**Hydro One Networks Inc.**

**EB-2018-0275 – Niagara Reinforcement Limited Partnership Application for 2019 Interim Revenue Requirement - Responses to OEB Staff Interrogatories**

Please find attached Niagara Reinforcement Limited Partnership (“NRLP”)’s responses to supplementary interrogatories received from OEB Staff dated January 10, 2020.

**Figure 1 - Organization Chart for the NRLP Shareholder Structure**

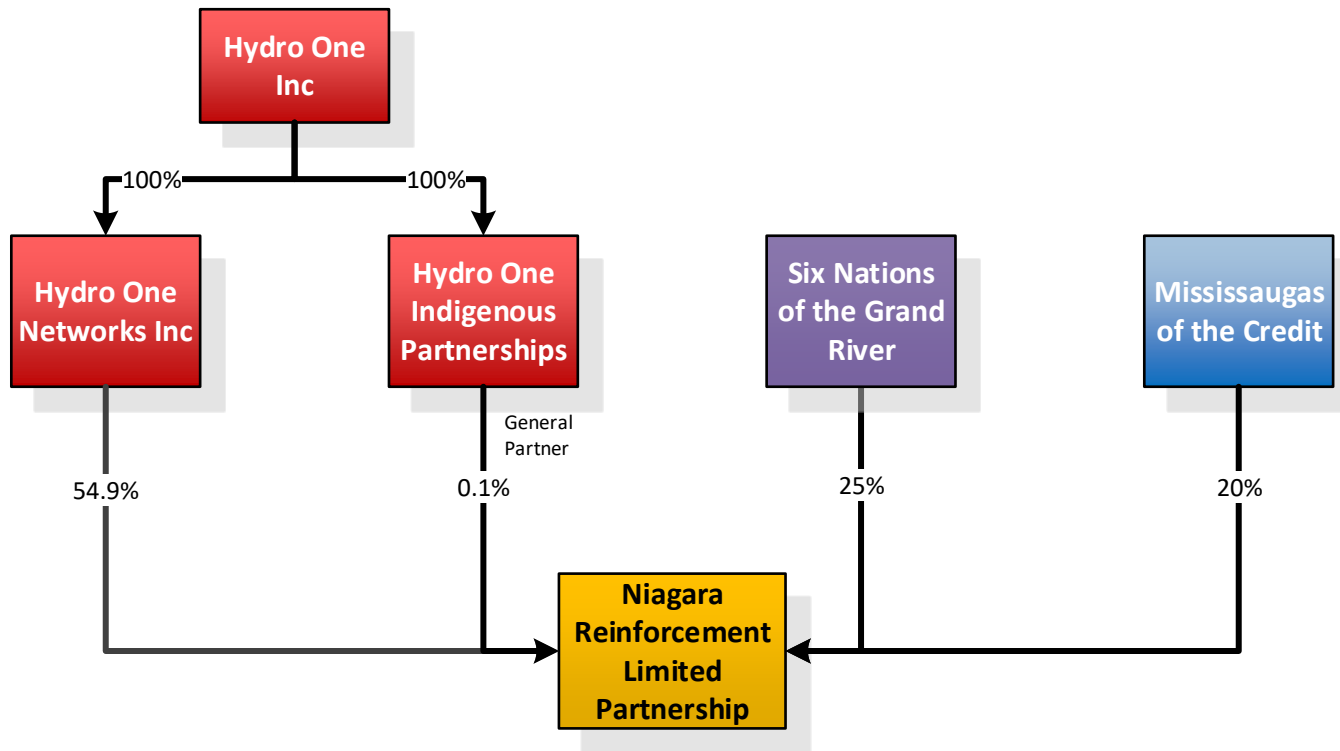
11 a) Figure 1 at Exhibit A, Tab 5, Schedule 1, Page 2 identifies Hydro One B2M LP as an  
12 NRLP shareholder. Please confirm Hydro One B2M LP as a shareholder or, if it is not,  
13 please provide a corrected version of Figure 1.

19 a) Figure 1 referenced above is in error. Hydro One Networks, not B2M LP, is the 54.9%  
20 shareholder in NRLP. A new Figure 1 is attached to this IR. NRLP apologizes for the  
21 confusion.
